HISTORIC AND DESIGN REVIEW COMMISSION

June 07, 2017

HDRC CASE NO: 2017-249
ADDRESS: 445 DEVINE ST
LEGAL DESCRIPTION: NCB 2957 BLK 1 LOT 12
ZONING: R-5 H
CITY COUNCIL DIST.: 1
DISTRICT: Lavaca Historic District
APPLICANT: Mauricio Namé
OWNER: Carlos Namé
TYPE OF WORK: Construction of a rear addition, exterior modifications, new 2-story rear accessory structure, hardscaping

2 NORTH EAST ELEVATION
3/8" = 1'-0"

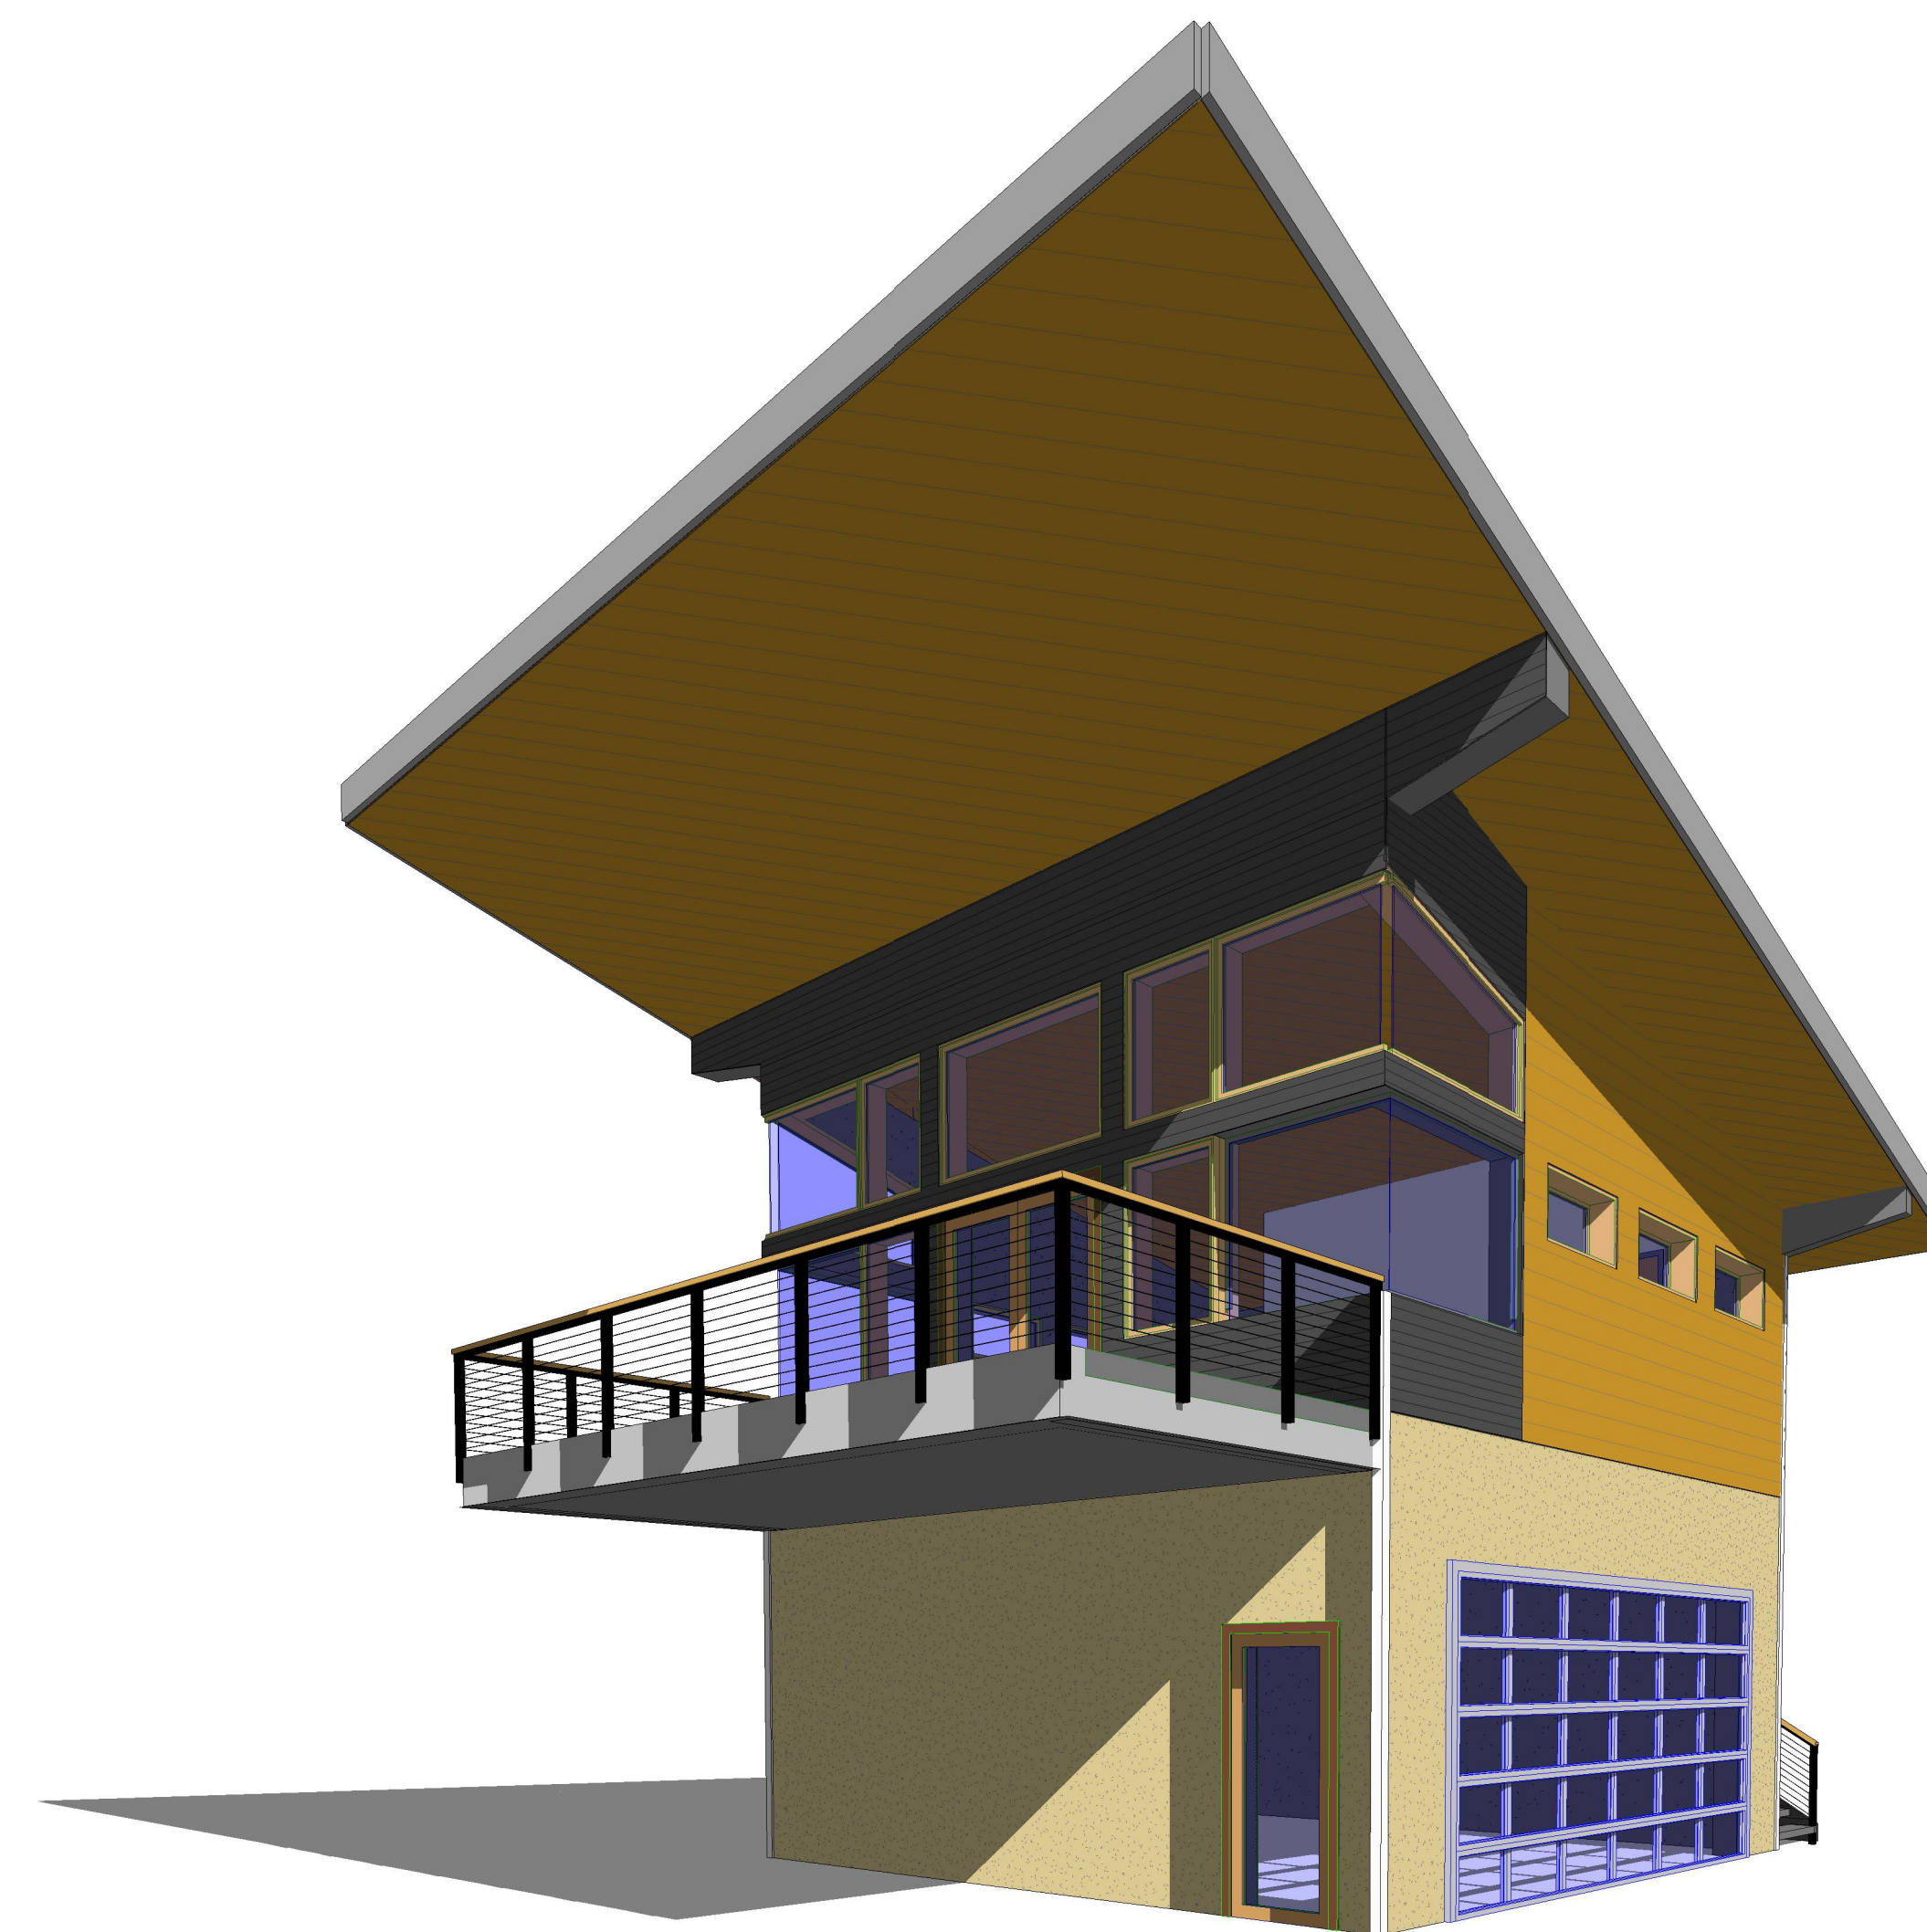
- q. **SCALE & MASS** – The applicant has proposed a two-story accessory structure with a sloped roof. According to the dimensions on the submitted elevations, the lowest point of the roof measures 21'-6" and the highest point measures 31'-3", both which are viewable from the public right-of-way. The first floor height measures 12'-0" and the second floor height measures 9'-6" up to approximately 18'-6" following the roof slope. The Historic Design Guidelines state that new construction should be consistent with the height and overall scale of nearby historic buildings. The ridge height of the primary gable of the existing historic home appears to measure approximately 20'-0" from the ground. In an elevation submitted by the applicant that indicates the height of the proposed accessory structure relative to the existing home, the new structure appears to eclipse the existing home's ridge height by over 10'-0" at its highest point. Additionally, the stairway on the side of the structure, which is viewable in full from the driveway, is almost the same height as the subordinate gable on the existing historic home. The height of the proposed structure would not only impact the view from the public right-of-way of the existing structure, but also affect the viewshed of the one and 1.5 story single family homes behind the lot

on Leigh St. Staff does not find the height of the proposed accessory structure consistent with the Guidelines or appropriate for the lot or the district.

- r. **ROOF FORM** – The applicant has proposed a two-story accessory structure with a sloped roof. The lowest point of the roof measures 21’-6” and the highest point measures 31’-3”. The roof is proposed to be standing seam metal. The guidelines stipulate that architectural details of new construction should keep with the predominant architectural style along the block face or within the district when one exists. Details should also be simple in design and should complement, but not visually compete with, the primary structure or adjacent structure. Staff finds the use of a sloping roof incompatible with the historic district, which is comprised of a high concentration of front and side gables or hipped roofs, especially within the immediate context of the lot. While similar roof styles can be found immediately adjacent to the Lavaca Historic District, there is no precedent for its use on a 2-story rear accessory structure within the district, especially in an area that is surrounded by one story single-family homes. Staff finds the proposal inconsistent with the Guidelines.

- s. **WINDOW & DOOR OPENINGS** – The applicant has proposed to install nine longitudinal rectangular fixed windows, five larger rectangular fixed windows with single muntins, and two large windows that follow the sloped roof pitch on the northeast and northwest elevations. According to the OHP Window Policy Document, windows used in new construction should maintain traditional dimensions and profiles found on the primary structure or within the historic district. Staff finds the windows inconsistent with the Guidelines.

- t. **MATERIALS: FAÇADE** – The applicant has proposed the use ICF concrete as the façade and structural material. The applicant has stated that the intention is to make the structure tornado-proof by utilizing this modern material. According to the Historic Design Guidelines for Additions, new construction should incorporate materials that complement the type, color, and texture of materials traditionally found in the district. Structures made exclusively of concrete are not characteristic of the district or surrounding context. Additionally, the elevations and renderings indicate multiple façade colors, but staff has not received material specifications that are tied to these delineations. Staff finds the proposal inconsistent with the Guidelines.

- Item 7, Staff recommends approval of the two porch railings and side staircase based on finding g and h.
- Item 8, Staff does not recommend approval of the 2-story rear accessory structure based on findings n through v. The application should address the following inconsistencies with the Guidelines if they wish to return with a new design proposal:

- i. That the applicant explores overall massing similar to historic structures and historic accessory structures in the vicinity as noted in finding p.

- ii. That the applicant reconfigures the roof form to be more consistent with the roof forms of the Lavaca Historic District as noted in finding q.
 - iii. That the applicant integrates window opening proportions that are more consistent with the Guidelines, the OHP Window Policy document, and the historic examples found in the Lavaca Historic District as noted in finding r.

- iv. That the applicant install windows that include traditional dimensions and profiles, be recessed within the window frame, feature traditional materials or appearance and feature traditional trim and sill details as noted in finding t.

- v. That the applicant incorporates architectural details and materials that are representative of the historic context of the district as noted in findings q through u.
